merit industries, inc.

FIELD BULLETIN

Date: 11-14-96

Figure 1 - Capacitor Installation Location, U31 of the CRT-260

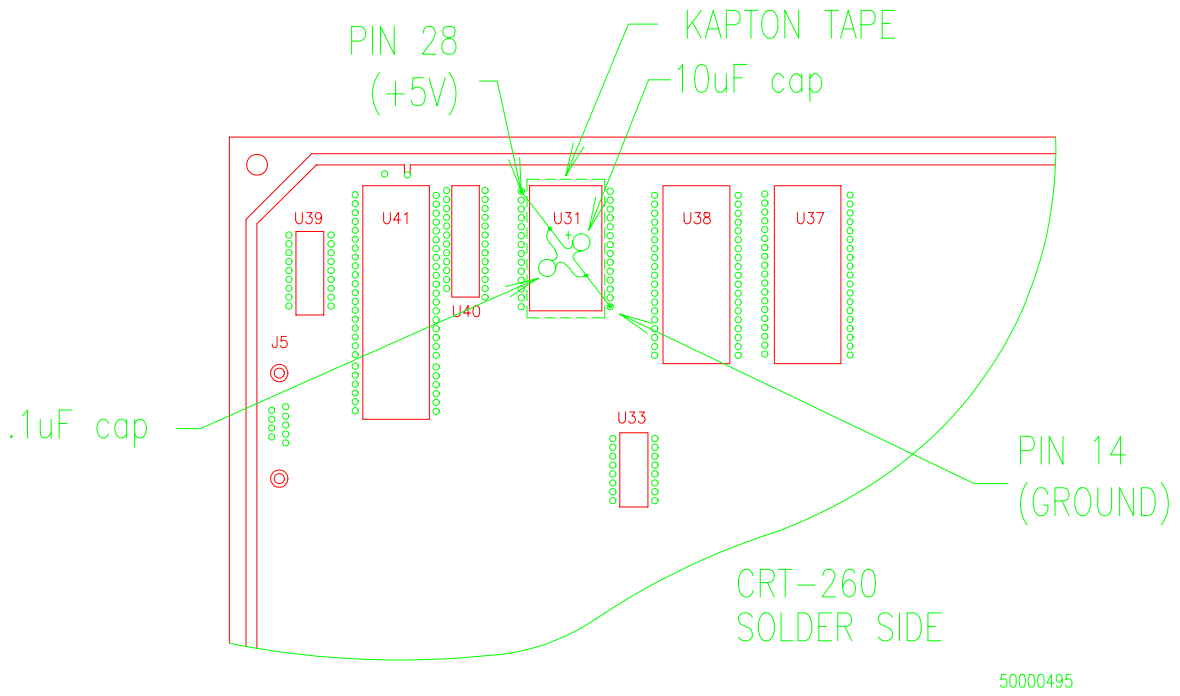
- Issue:** Internal RAM clock not working properly.
- Games affected:** Megatouch Tournament games in which the system clock has exhibited a problem keeping the correct time. This change is *not* needed if your game has not exhibited this problem.
- Symptoms:** Tournament system clock gains/loses time.
- Cause:** Noise spikes interfering with the clock signal.
- Solution:** Add 10 μ F tanta capacitor (Merit P/N CP4499) and .1 μ f ceramic capacitor (Merit P/N CP1026) to U31 on the CRT-260. A kit is available from Merit Customer Service at 1-800-445-9353.

4. Solder the .1 μ F ceramic capacitor across the 10 μ F tanta capacitor, as shown in Figure 1.
5. Turn the board to the solder side and find the location of the U31 NV RAM chip.

6. Place the piece of kapton tape between the pins for U31 to protect the traces.
7. Solder the positive (“+”) lead, of the 10 μ F tanta capacitor, to Pin 28 of U31 and solder the other lead to Pin 14. See Figure 1. **NOTE: BE CAREFUL NOT TO ALLOW THE CAPACITOR LEAD, OR THE SOLDER, TO CONTACT ANY OF THE NEIGHBORING PINS.**
